NASA

SECTION 7

System Integration Inputs Were Matched Against Orbiter Tile/RCC to Determine Critical Locations

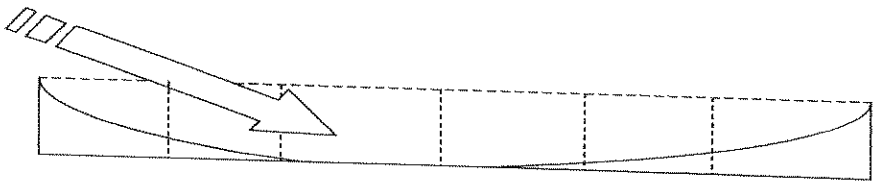
Damage Results From "Crater" Equations Show Significant Tile Damage

- "Crater" indicates that multiple tiles would be taken down to densified layer
  - However, program was designed to be conservative due to large number of unknowns
  - Crater reports damage for test conditions that show no damage

Thermal Analysis Assessment of Debris Impacted Lower Surface in STS-107 Mission Locations

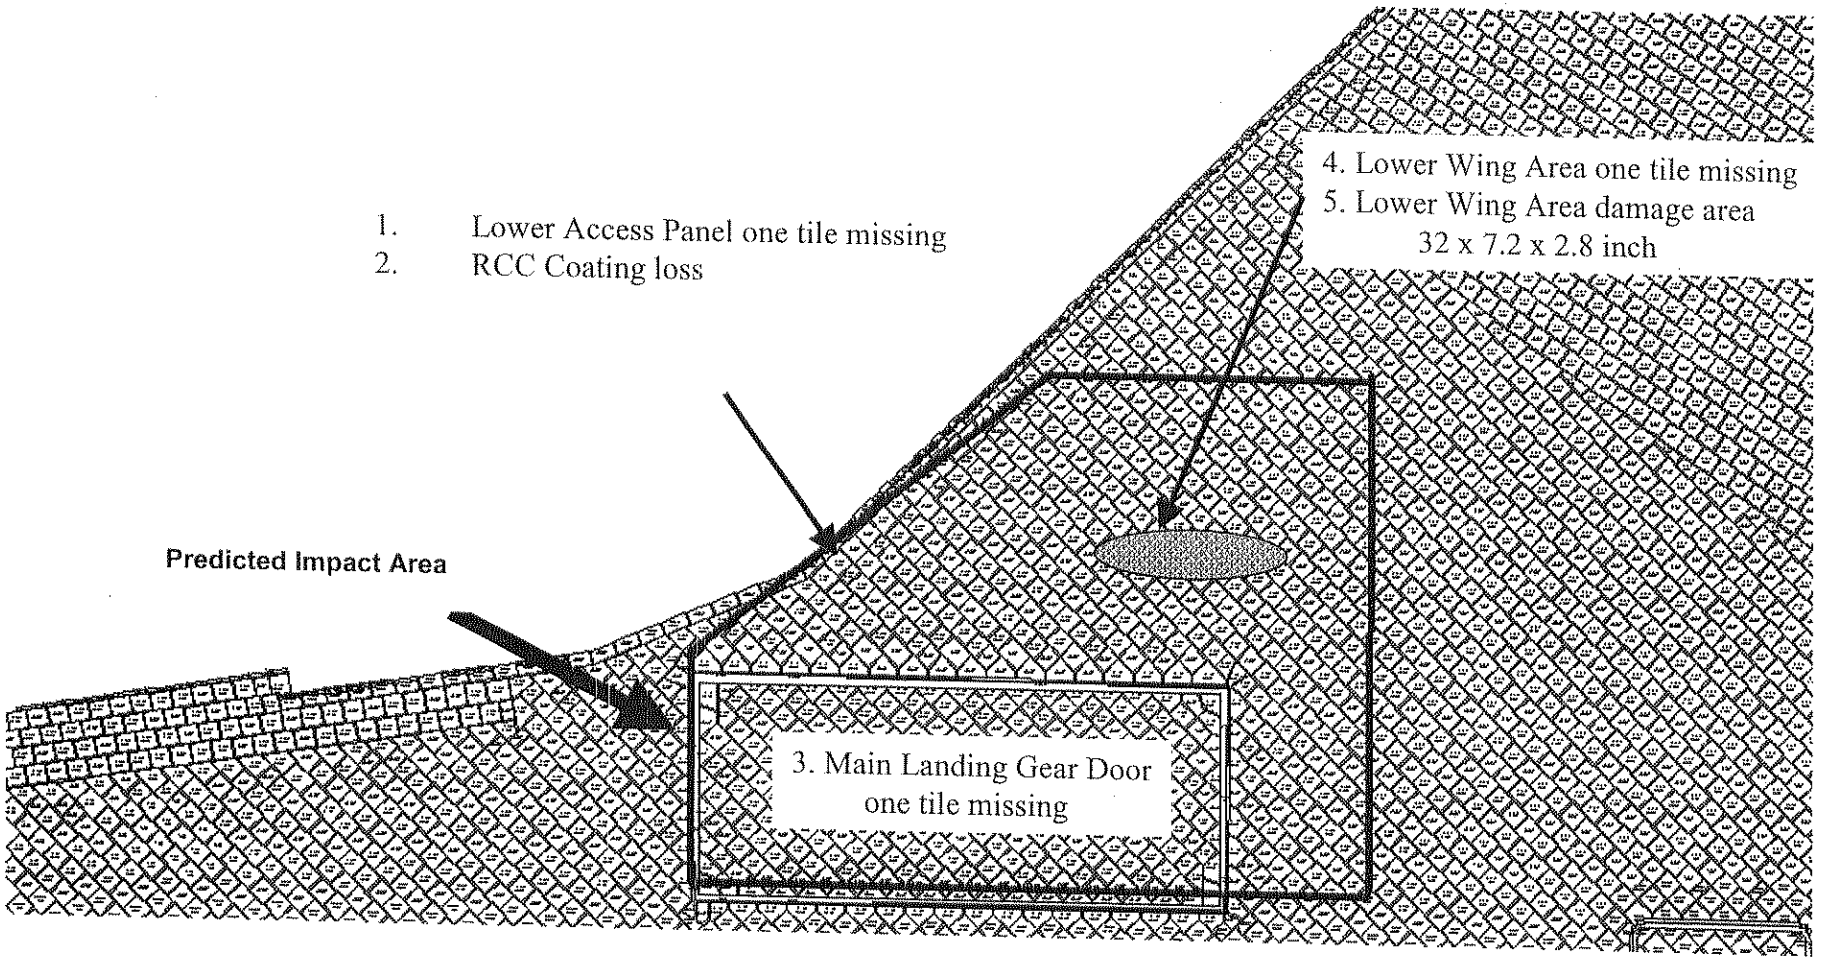
Impacted Lower Surface Location Thermal Predictions

Case	Location	Assumptions	Results
1	Access Panel (one tile missing)	Loss to last layer of TMM Densified layer ~ .2 inches	Temperature of Al Tube Carrier 790 °F No issue
2	RCC Panel 9 Lower Flange OML (Coating Missing)	Coating loss and Carbon substrate exposed	Substrate thickness: 0.193 inches Loss .09 inches No issue
3	Main Landing Gear Door (one tile missing)	Loss to last 2 layers of TMM Densified layer ~ .4 inches	Temperature of Structure 540 °F No issue
4	Lower Wing Area (one tile missing)	Loss to last 2 layers of TMM Densified layer ~ .4 inches	Temperature below 350 °F design req. No issue
5	Lower Wing Area (32 x 7.2 x 2.8 Inch) Damage	Loss to last layers of TMM Densified layer ~ .2 inches	
6	Main Landing Gear Door (several tiles Lost)	Loss to last layers of TMM Densified layer ~ .2 inches

Wing Lower Surface M/OD Failure Criteria

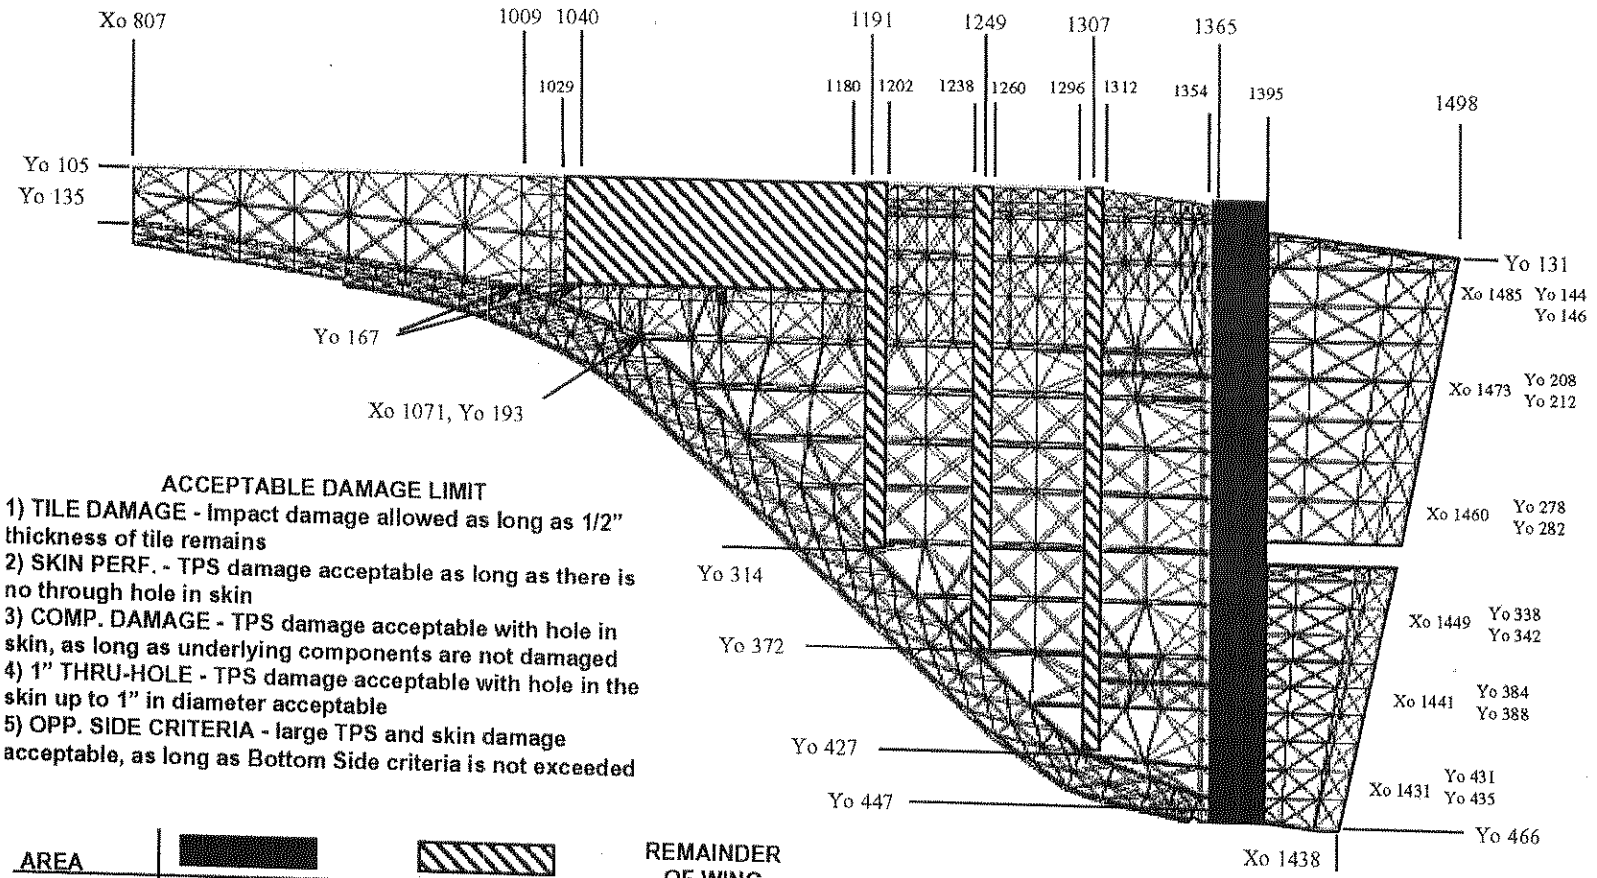
ACCEPTABLE DAMAGE LIMIT

1) TILE DAMAGE - Impact damage allowed as long as 1/2" thickness of tile remains
2) SKIN PERF. - TPS damage acceptable as long as there is no through hole in skin
3) COMP. DAMAGE - TPS damage acceptable with hole in skin, as long as underlying components are not damaged
4) 1" THRU-HOLE - TPS damage acceptable with hole in the skin up to 1" in diameter acceptable
5) OPP. SIDE CRITERIA - large TPS and skin damage acceptable, as long as Bottom Side criteria is not exceeded
